State of Ohio Environmental Protection Agency

Re: Construction Storm Water Inspection at Van Der Burg Dairy LLC

Figure 1 Inadequate vegetative cover

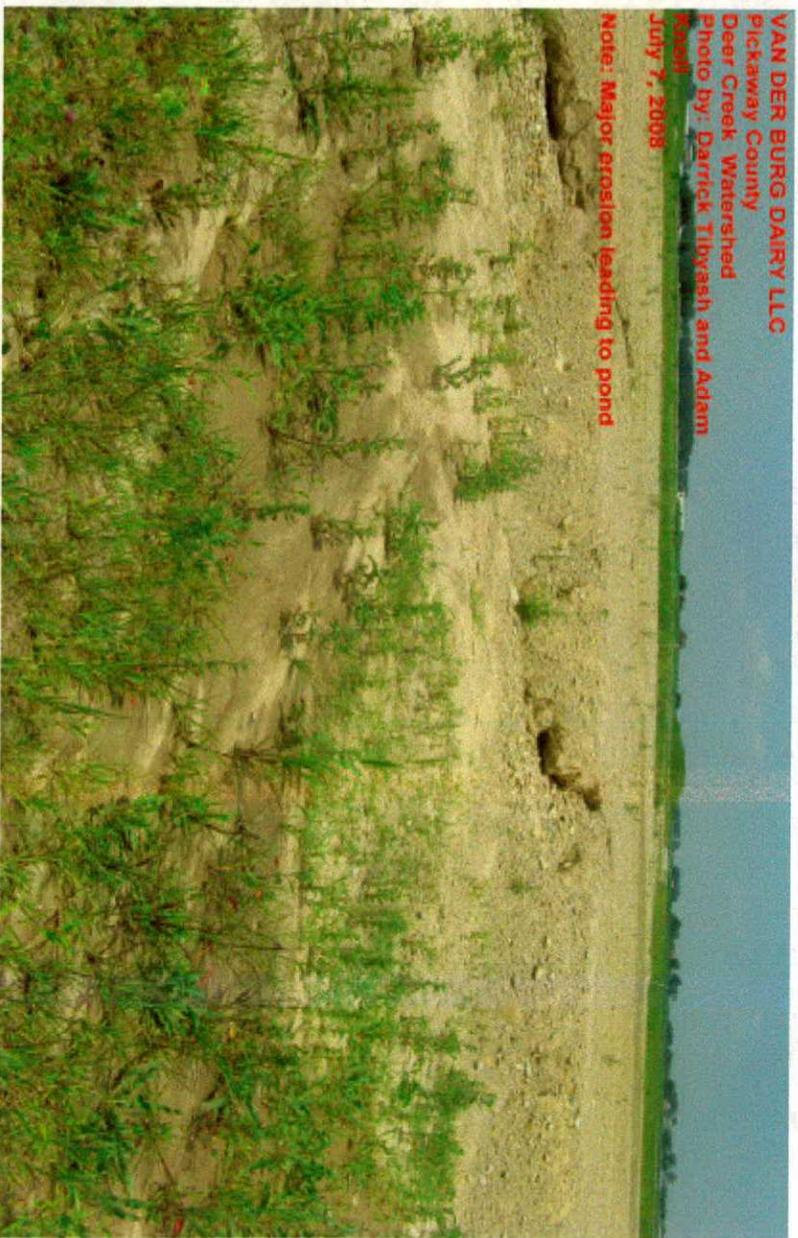
- Upon inspection it appeared that this site has been abandoned for some time. The lack of activity and inadequate vegetative cover is resulting in significant erosion throughout the entire site (See Photo Figure 1 and 2). This erosion is causing excess sediment to be deposited in the pond (See Photo Figure 3).
- The detention basin noted onsite must be modified to address sediment control via the installation of a temporary riser. This will allow for additional settling time for the suspended solids to settle prior to a final discharge from the site (See Photo Figure 4).
- Be aware the General Permit states that all barren areas which remain idle in excess of 21 days must be protected from erosion within seven days of the last earth disturbing activities. In addition, erosion protection must be implemented for all areas of final grade within seven days (See Photo Figure 5).

VAN DER BURG DAIRY LLC
Pickaway County
Deer Creek Watershed
Photo by: Darrick Tihyash and Adam Knapp
July 7, 2008
Note: Site appears vegetated but vegetation is inadequate
